CERTIFICATE OF APPROPRIATENESS

**RE: Application Number 20-6987; 2447 Cass; Cass-Henry Historic District
Project Scope: Rehabilitate Apartment Building**

RE: 2447 Cass Avenue—Hotel Ansonia/Grande Apartments

Sheet
7A401.1

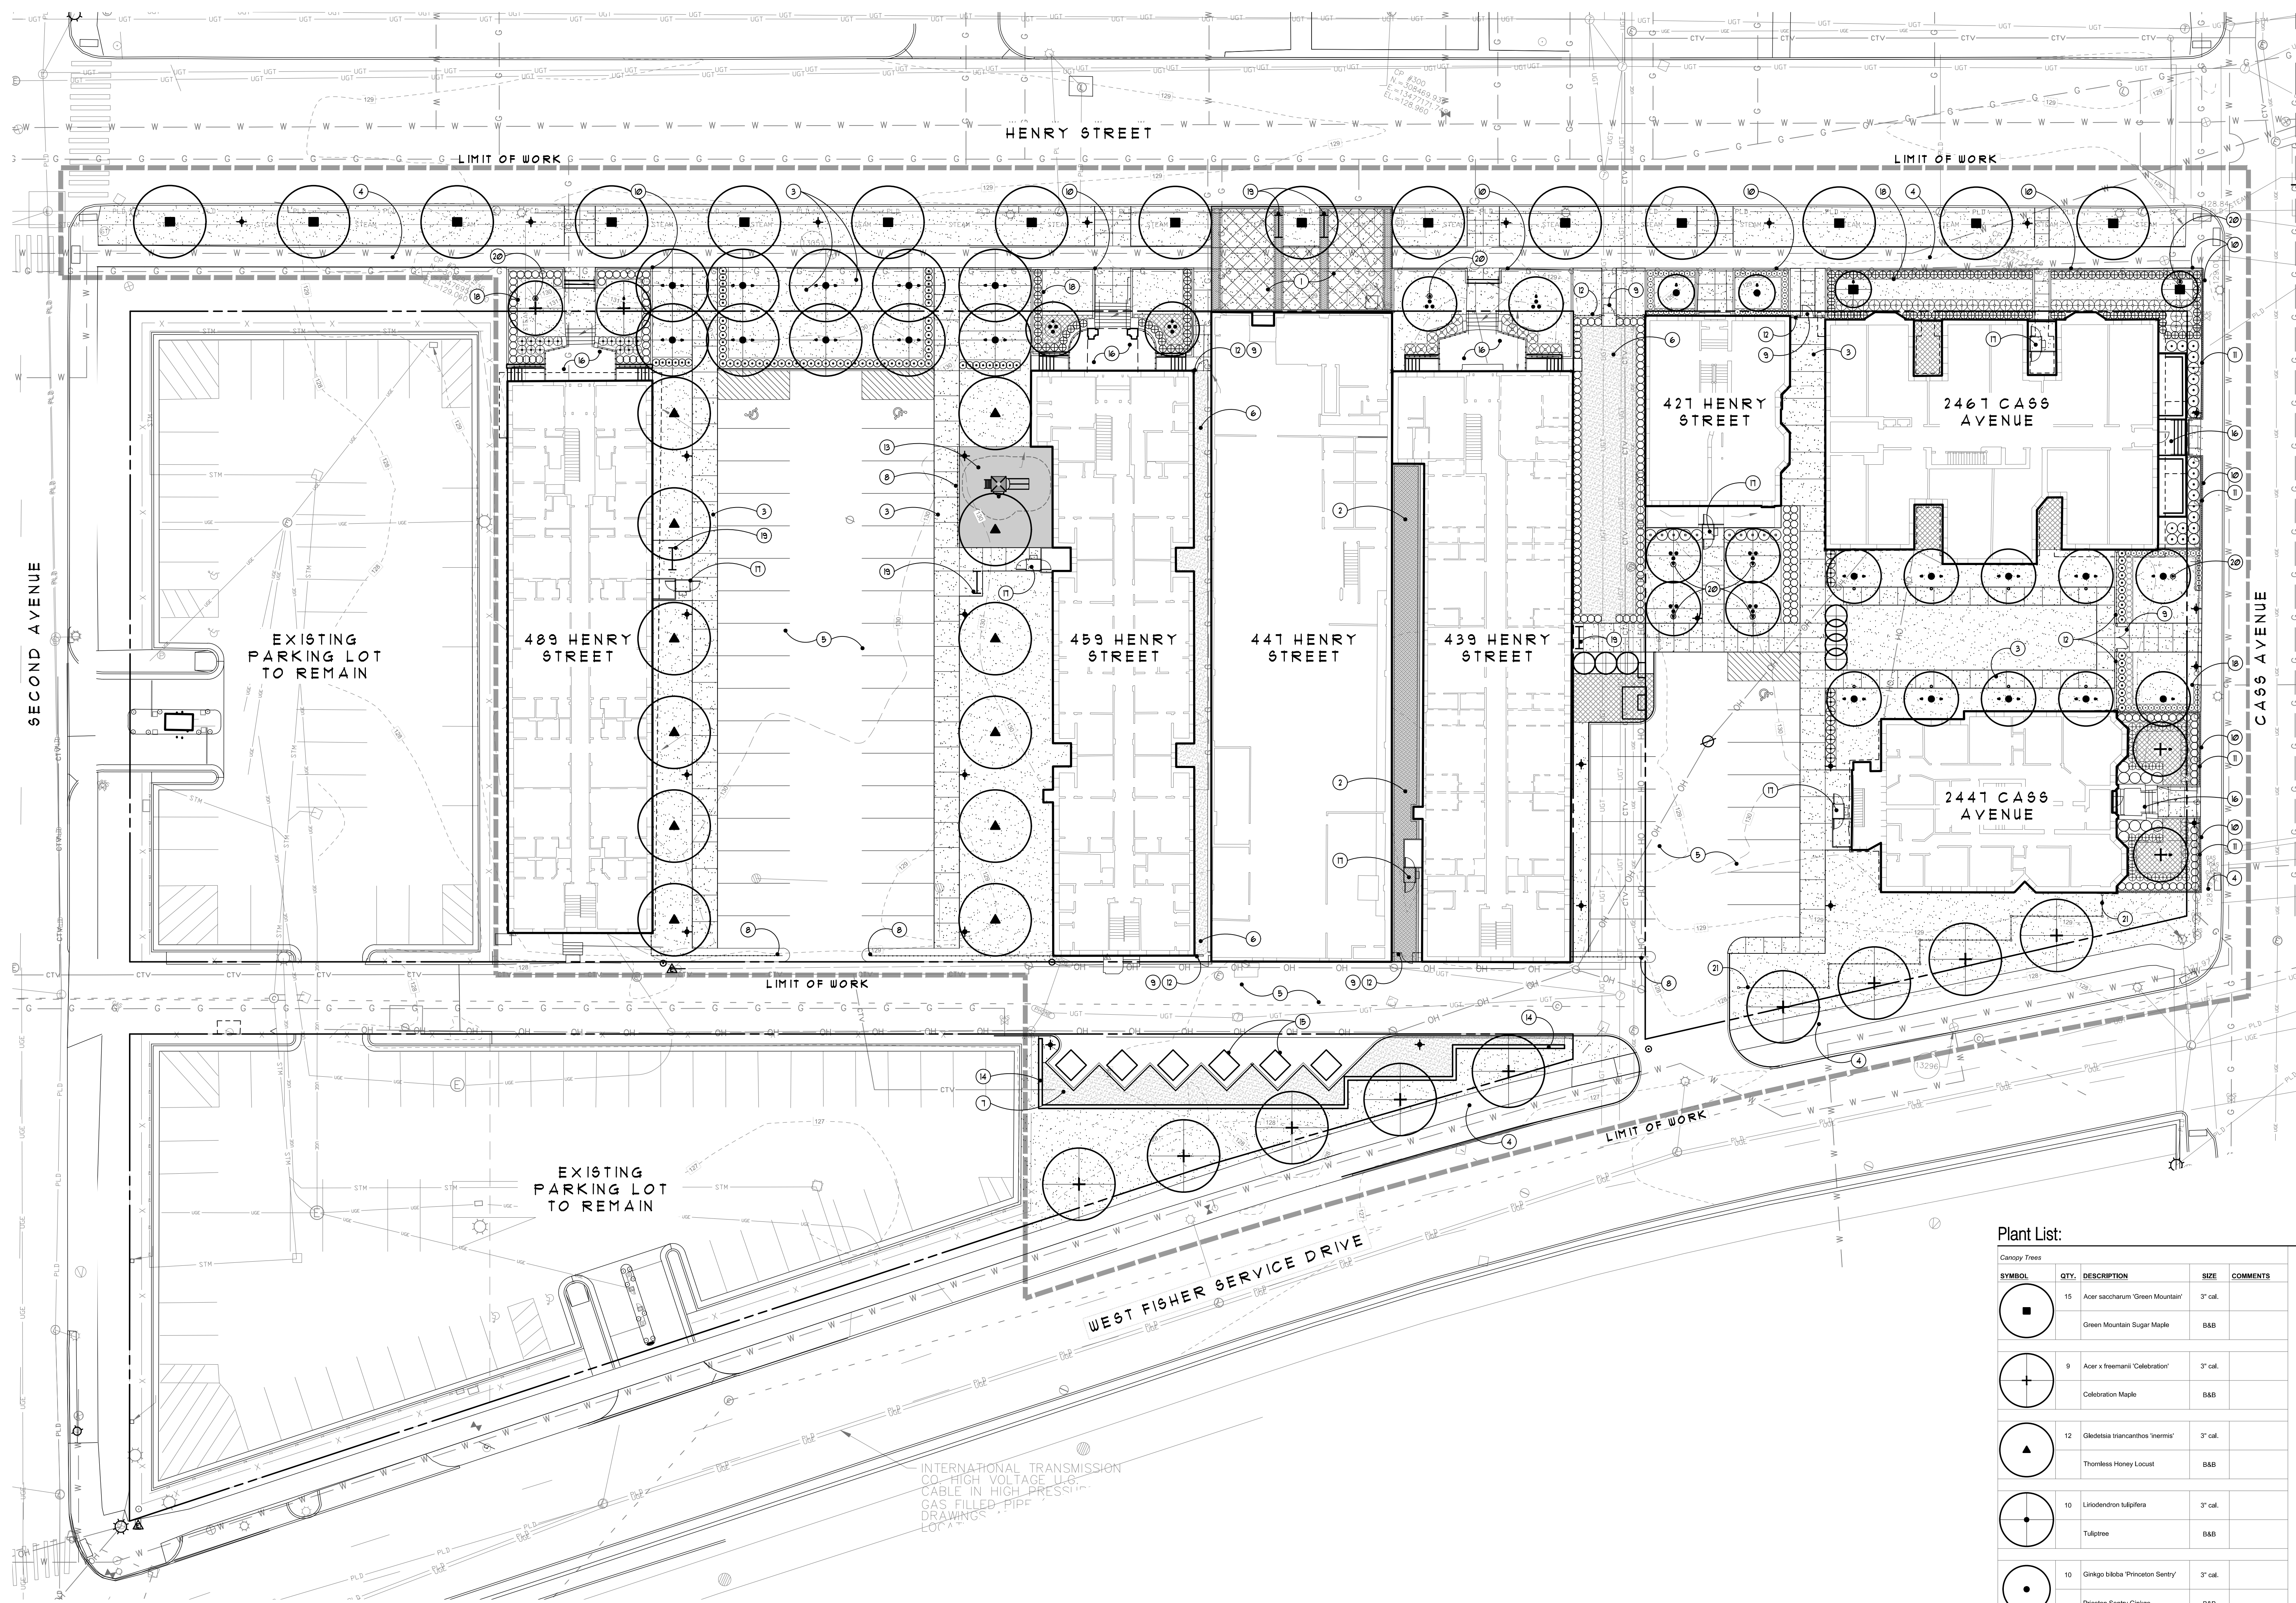
And, as per the submitted documents, specifically drawings 7A101 (floor/roof plans) and 7A401, 7A401.1 (elevations).

- Staff review of the submitted construction drawings will include the identification of specific standards concerning repair and/or replacement of deteriorated character-defining features, and related standards concerning the qualifications of historic preservation contractors retained to perform the work.
- Staff review of the submitted construction drawings to specifically include review of specifications/cut sheets for lighting, windows, doors, ADA lifts, signage, paint removal, paint colors, and other exterior elements/selections not yet finalized, with staff authority to approve if per the Secretary of the Interior's Standards, the district's Elements of Design, and otherwise consistent with Commission intent and guidelines.
